SERVICE BULLETIN	
Product:	Dishwasher
Bulletin Number	ASC20151026002
Bulletin Date:	4/20/2016
Models:	DW80H9930US/AA, DW80H9940US/AA, DW80H9950US/AA, DW80H9970US/AA, DW80J9945US/AA, DW80J7550UG/AA, DW80J7550US/AA, DW80J7550UW/AA

SUBJECT: Water leak from corners of dishwasher, version 00

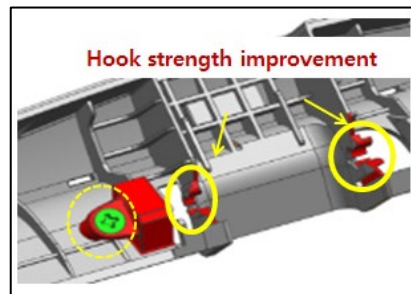
Issue: If the Assy Vane is not fully connected to the Assy Motion, water from the Assy Nozzle-Lower can miss the Assy Vane and cause a leak.

Solution: Replace the Assy Vane, part number DD97-00206B. The new Assy Vane has increased hook strength to prevent accidental separation of the vane.
